Re: **Docket No. 40-8903**
License No. SUA-1471
Evaluation of Field Measurements on Rock Cover for LTP

**EVALUATION OF FIELD MEASUREMENTS ON ROCK COVER OF LARGE TAILING
IMPOUNDMENT, HOMESTAKE GRANTS PROJECT**

Evaluation of Field Measurements on Rock Cover
of Large Tailing Impoundment

Rock Sample Locations

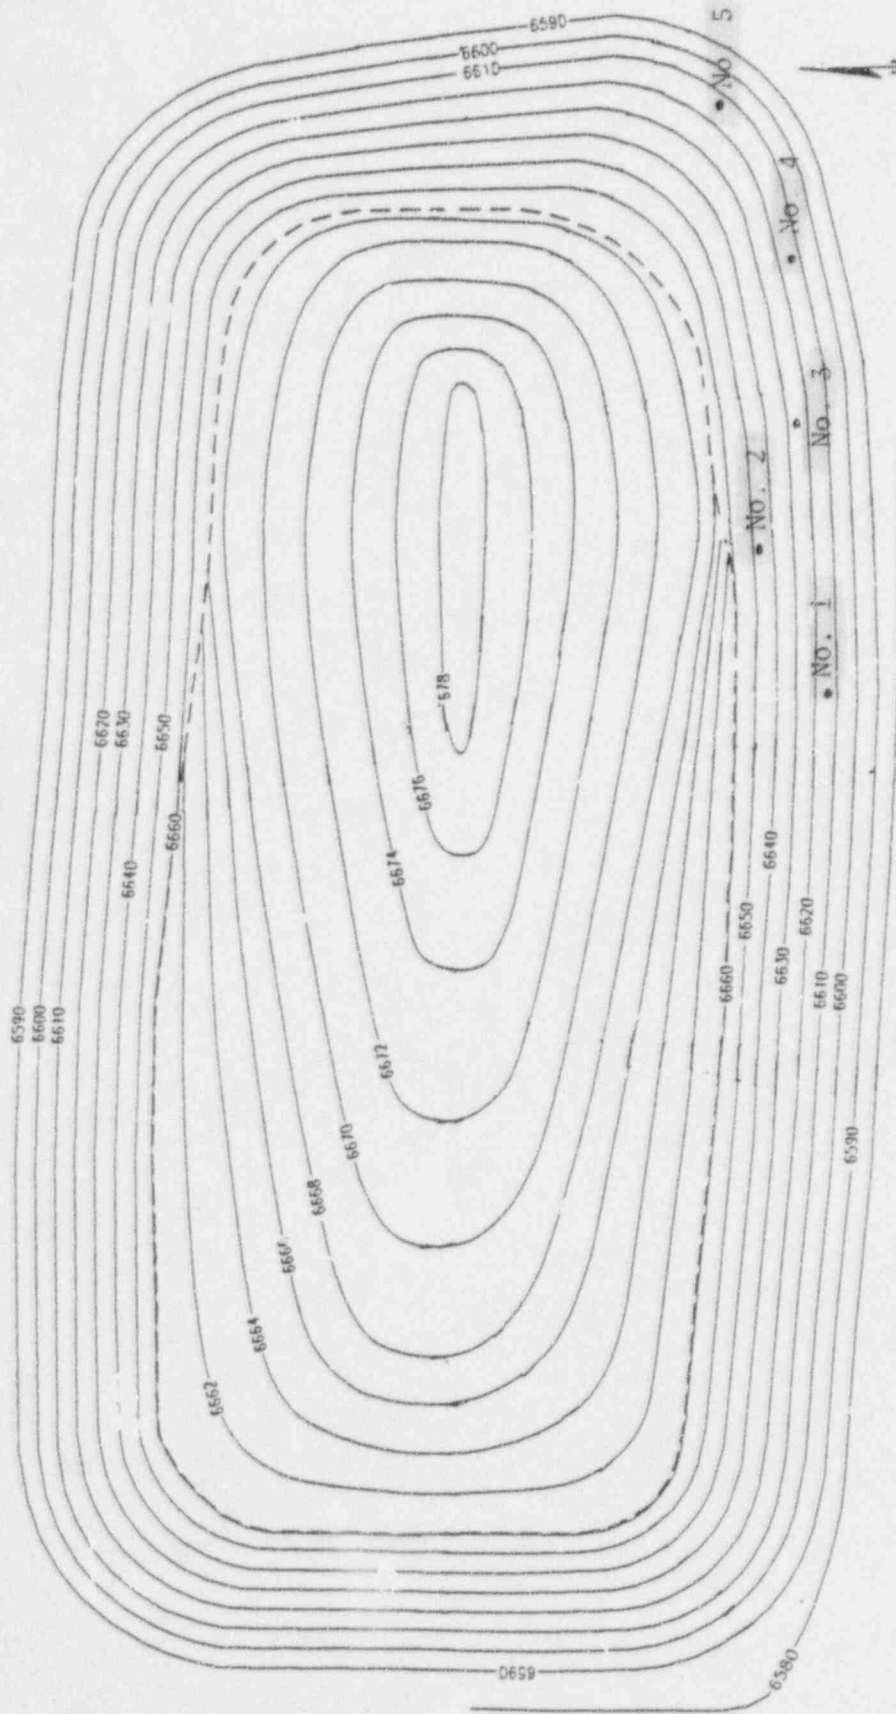
The attached table entitled *EVALUATION OF ROCK COVER MEASUREMENTS AS REPORTED BY HMC ON 11/1/96* summarizes my review and evaluation. As discussed with Mr. Johnson (telcon, 4/4/97), I assumed initially that the rock cover at each measured location consisted of one layer of rock, the thickness of which would then represent the d_{100} of rock at that location. Using the design relationships between d_{100} and d_{50} , as described in the reclamation plan Appendix C, I calculated the maximum, minimum, and average d_{50} values that would correspond to each d_{100} . The minimum d_{50} is the value used in the determination of rock sizes needed to protect against PMP runoff, and the smallest d_{50min} value based on the field measurements is 4.2 inches at sample location #1 (shaded number in attached table).

Figure C10.2 - Reclaimed Large Impoundment With Slope Elements Used for Runoff Erosion Analysis

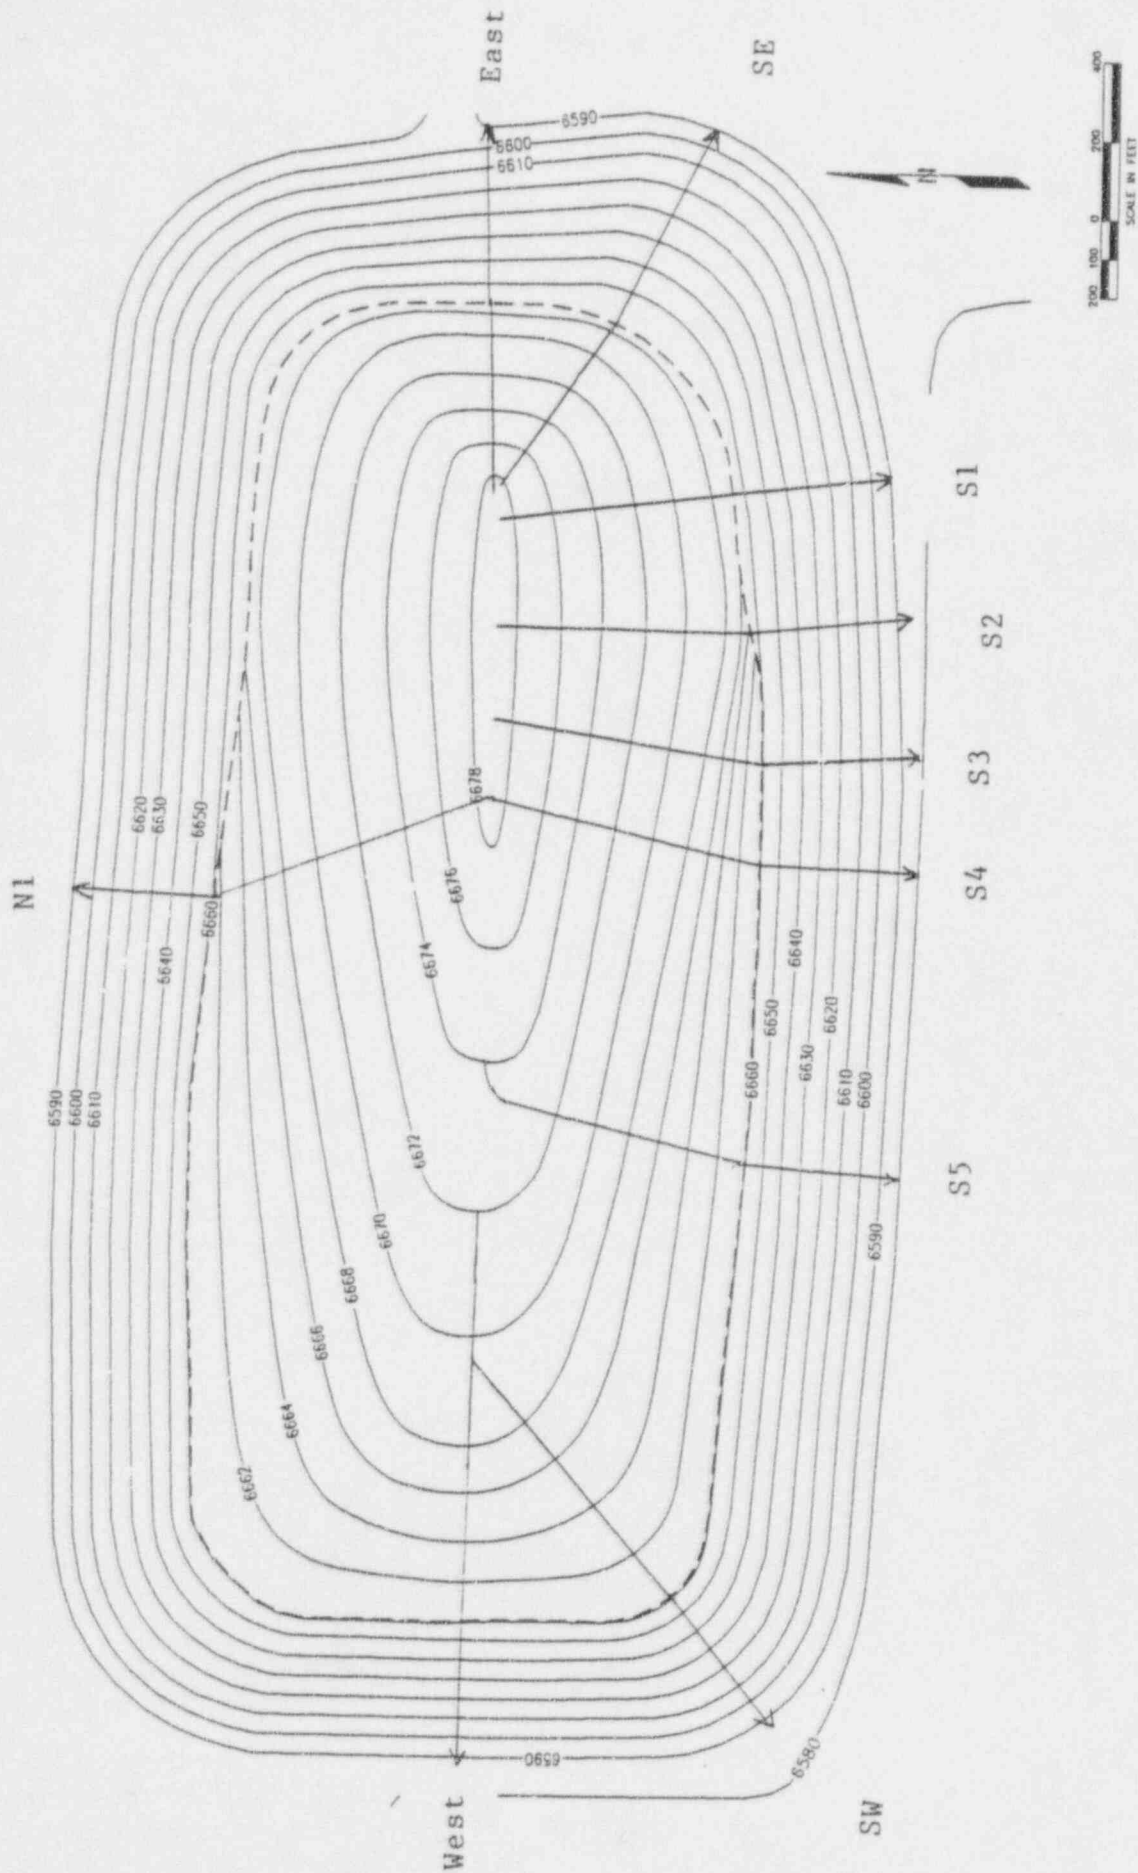
For any given slope angle and rock source, all factors of this equation are constants except for the discharge, q , and its factors i and a , both of which are functions of the flow path length. In preparing the reclamation plan, the design configuration of the reclaimed tailing pile was examined to determine the range of flow paths that will produce discharge to the tops of the outslopes. Ten such flow paths on the large pile were analyzed, as illustrated on Figure C10.2 (attached) in Appendix C10. Using a spreadsheet format to display the

Not surprisingly, the largest rock (4.2 inches) is required for the outslope portion of the longest flow path, "West" on Figure C10.2 and Calculation C10.1A.1. This became the design rock size for all outslopes of the large pile, regardless of the fact that this size is needed only for a small percentage of the total outslope surface. Consequently, an additional margin of conservatism in rock sizing has been applied over most of the outslope surface.
